Hi-Fi Products Service Bulletin

Model: MDS-101

No. 474

Subject: No Playback of MO Discs

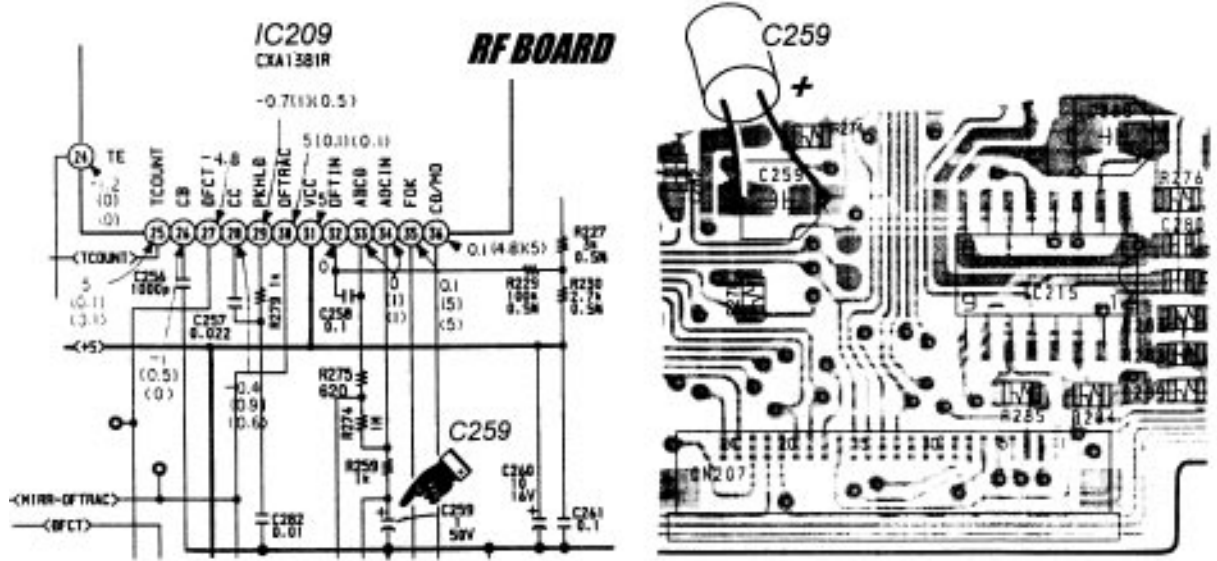
MO discs will display irregular movement on playback such as; no rotation, no focus servo, and ejecting. No problem seen when playing pre-recorded non-MO MiniDiscs.

Solution: Replace C259 with the part listed below.

REF	FORMER		NEW	
	DESCRIPTION	PART NUMBER	DESCRIPTION	PART NUMBER
C259	1UF/50V ELECTROLYTIC CAPACITOR	1-126-193-11	1UF/50V ELECTROLYTIC CAPACITOR	1-126-301-11
